## ULTRA SIDECAR AUDIO

### Purpose

Harley-Davidson has learned that early 2004 FLHTCUI model motorcycles lack the necessary wiring for operation of the Ultra sidecar audio system. In the interest of customer satisfaction, Harley-Davidson has elected to provide an adapter harness for all those vehicles equipped with the Ultra sidecar to ensure that the sidecar audio system is fully operational.

Figure 1. Ultra Sidecar Audio Adapter Harness Kit (Part No. 94264)

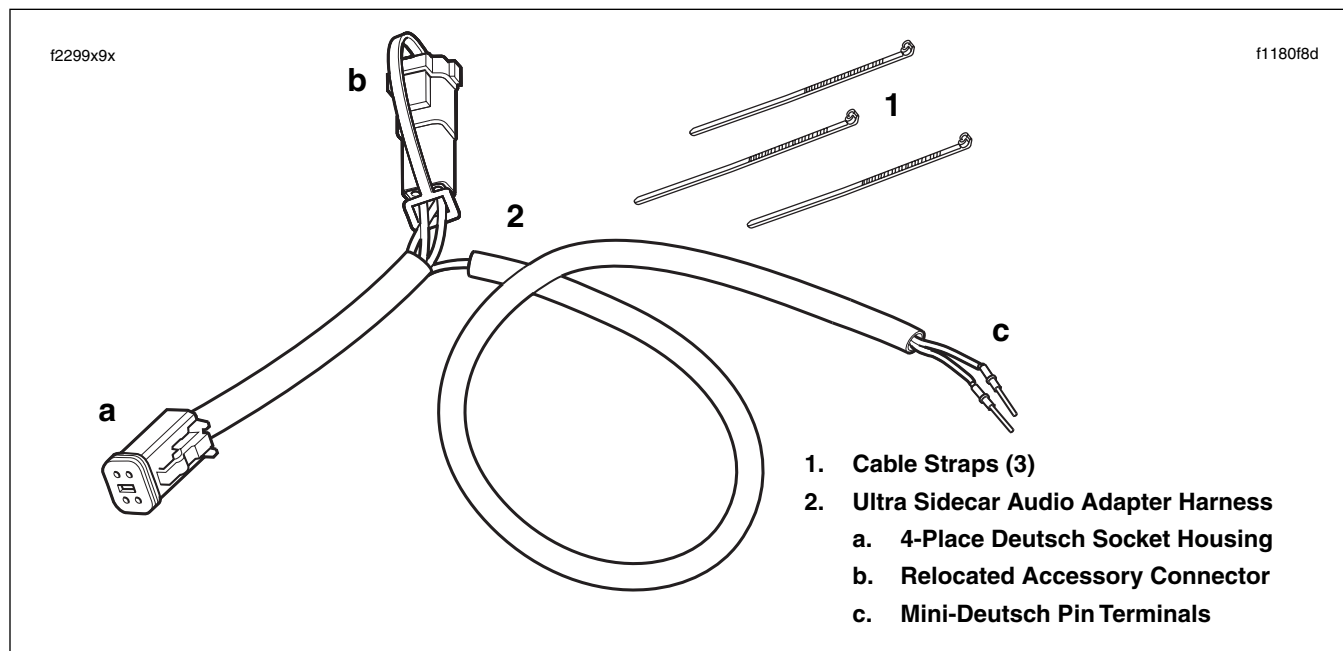
1. Order the Ultra Sidecar Audio Adapter Harness Kit (Part No. 94264). See Figure 1.

**Figure 2. Install Three Cable Straps**

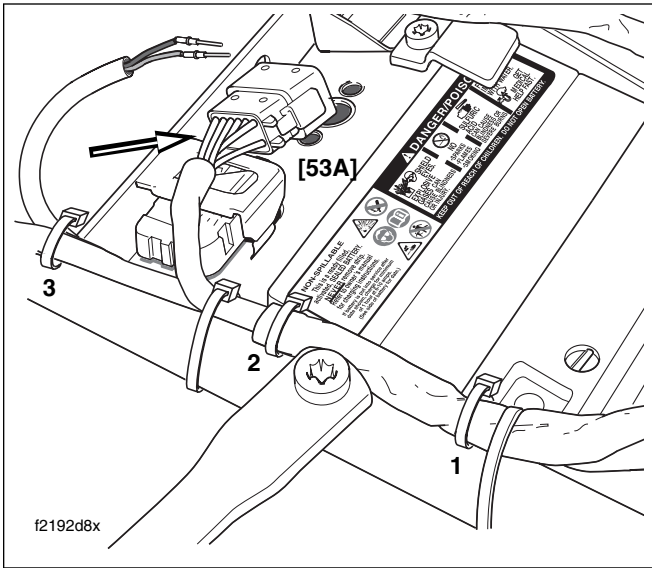
7. Loosely install three cable straps from kit to secure audio adapter harness to motorcycle audio harness. See Figure 2.
8. Release console pod/sidecar audio connector [53], 12-place Mini-Deutsch, from attachment clip anchored in hole of frame crossmember.

11. Push **orange/red wire** pin (power) on adapter harness through wire seal into **cavity 1** of pin housing. Push **black wire** pin (ground) through wire seal into **cavity 5**. See arrow in Figure 2.
